FD2 VD Mod-1 Design Changes

24 June 2023

- Pin Dimension

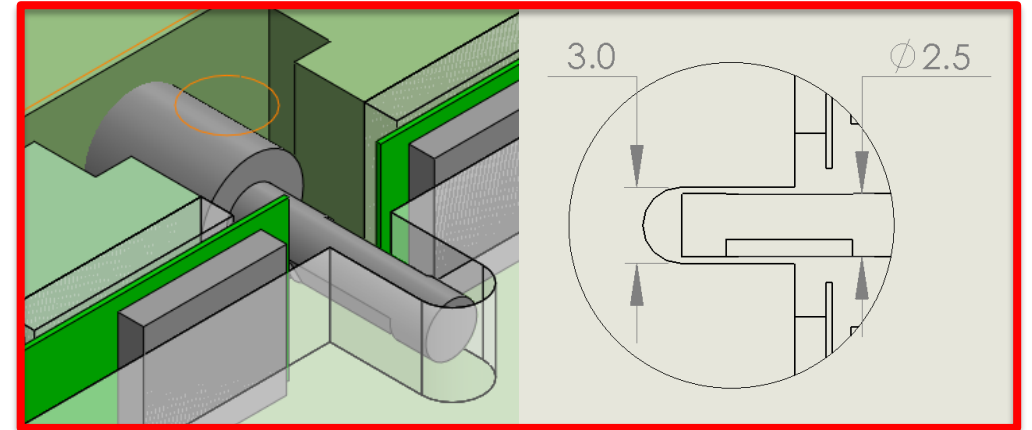
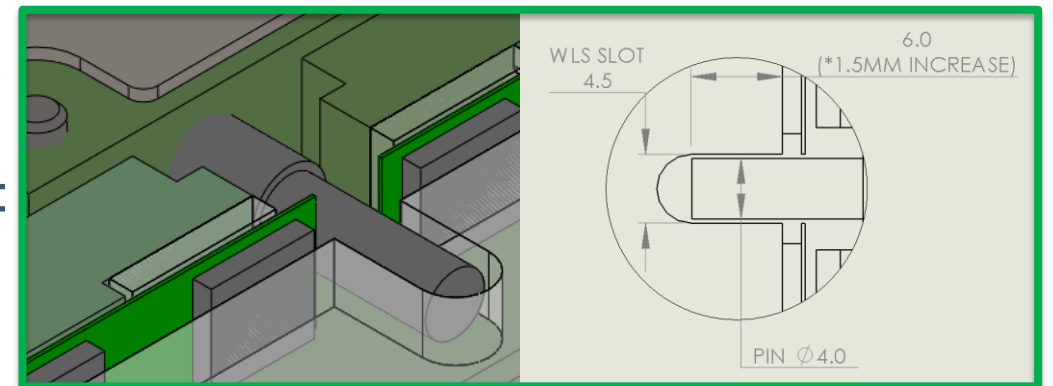
- Pin Dimension
 - WLS-locating pins bent by suspected shipment mishandling
 - 2.5mm pin dia. driven by pre-V5 3mm slot in WLS
- Slot must increase from 3mm->4.5mm at minimum
- Improves:
 - *Safety during shipping*
 - *Easier assembly*
 - *Looser assembly tolerances*

- WLS slot width increased 1.5mm
 - (3mm -> 4.5mm)
- WLS slot depth increased 1.5mm
 - (4.5mm -> 6mm)
 - Alleviates tolerance stack-up concerns during frame assembly *and* cooldown
- Pin diameter increased 1.5mm
 - (2.5mm -> 4mm)
 - Vastly improves confidence in pin function, in terms of both WLS capture *and* structural integrity.

Mounting Components

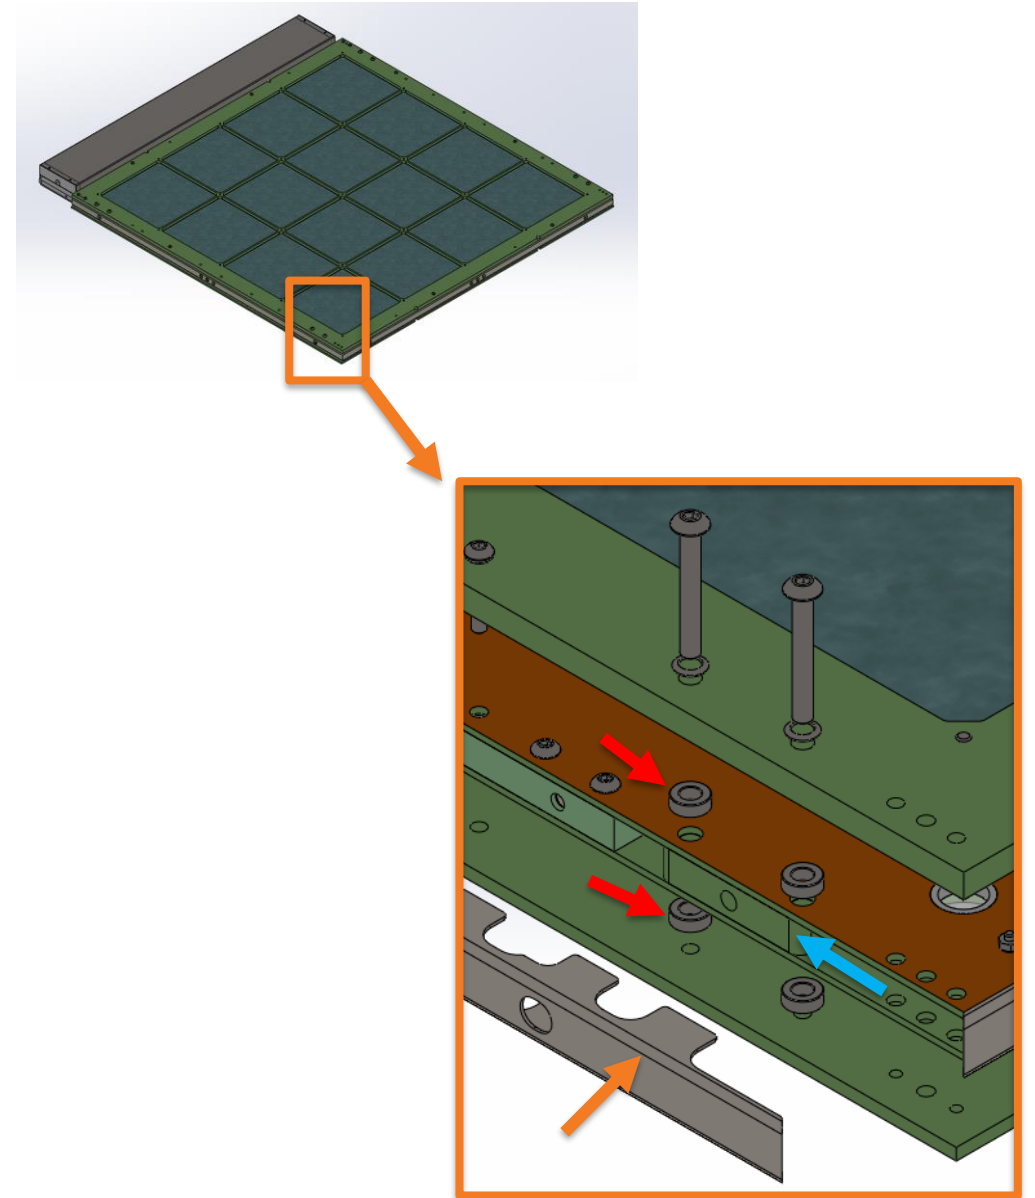
- Mod-0 Issues
 - Original design intent called for perimeter faraday c-channel & electronics enclosure installed at final step
 - Shifting design requirements for turnkey WLS housing *prior* to Frame install complicated the procedure
 - External Mount Blocks (Blue) and Dichroic Frame Spacers (Red) float until fasteners are installed.
 - When installed earlier, Faraday C-Channel Shielding (Orange) blocks placement of spacers and blocks
 - Spacers are free to slide out of alignment or onto WLS

Mounting Components

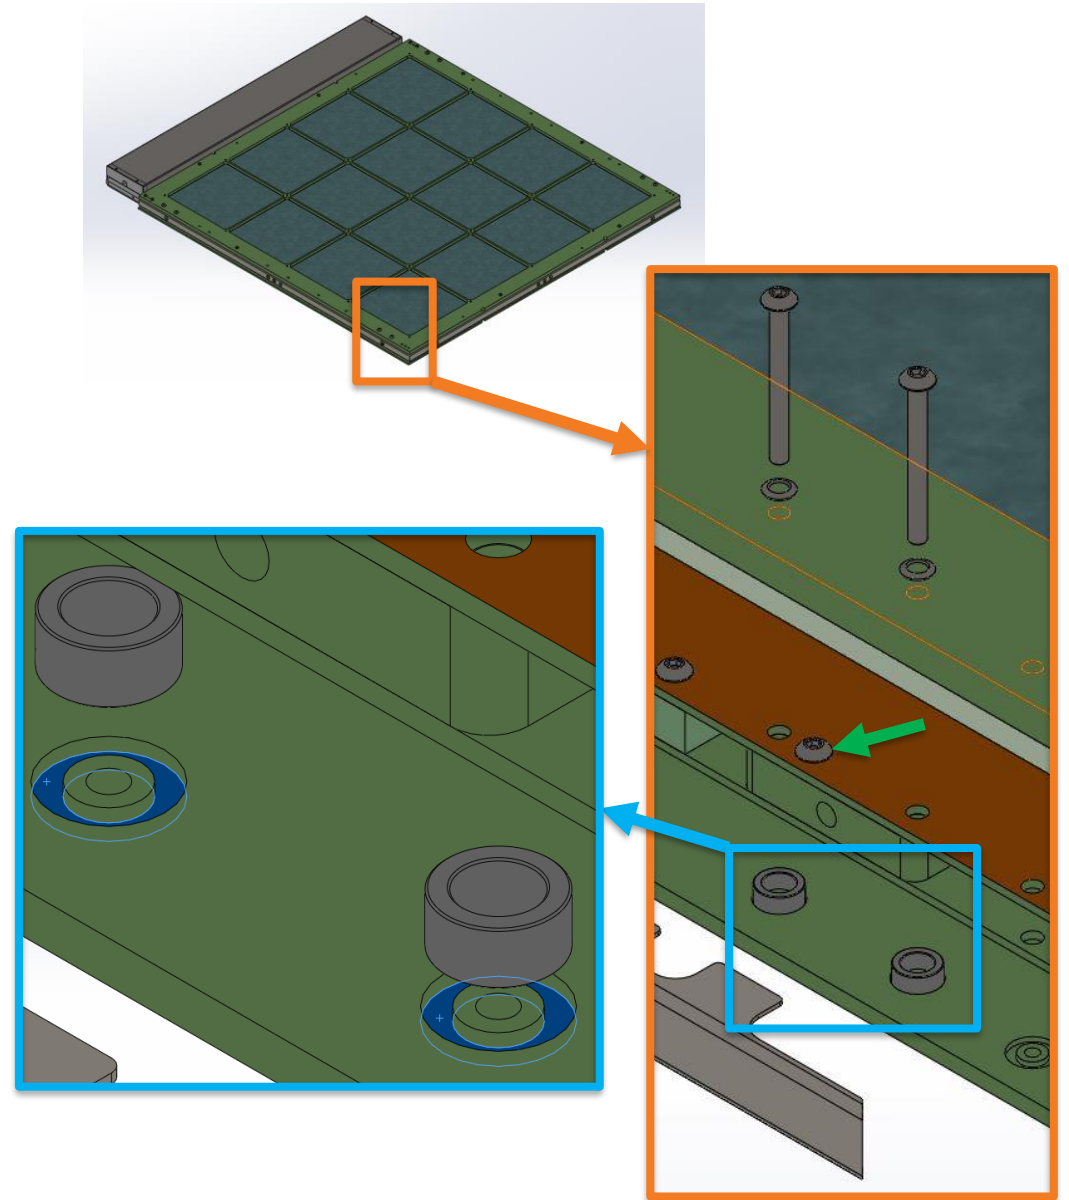
- Mod-1 Proposed Solution
 - (Green) Fasten External Mount Block to Cu-Clad Faraday Cage
 - *Non-Structural*
 - Only intended for “tacking” block prior to final assembly, will not slide out of alignment
 - Does not need to be removed later
 - (Blue) All Spacers become integral to frame
 - Thin layer of epoxy in spacer pockets
 - *Non-Structural*
 - Temporarily mates spacers to frame during assembly

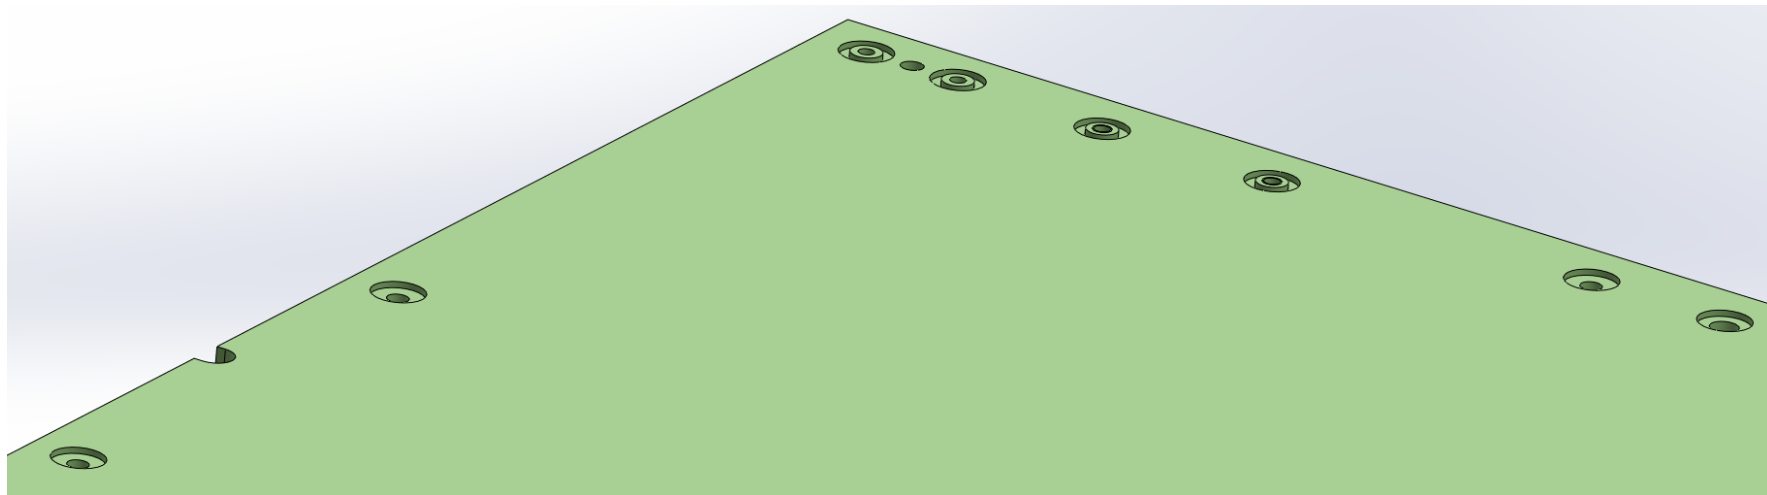
- 1) Vastly simplified assembly – Minimized free-floating components. Epoxy and forget.
- 2) Some additional flexibility in dichroic frame spacing
- 3) Reduced Hardware Variety
 - All fasteners become M3
 - Same spacer size throughout

- 1) Increased manufacturing time
 - Added manufacturing step in membrane back plates
 - Small increase for all others (we're already pocketing the others – design should capitalize on this)
- 2) Additional QC item
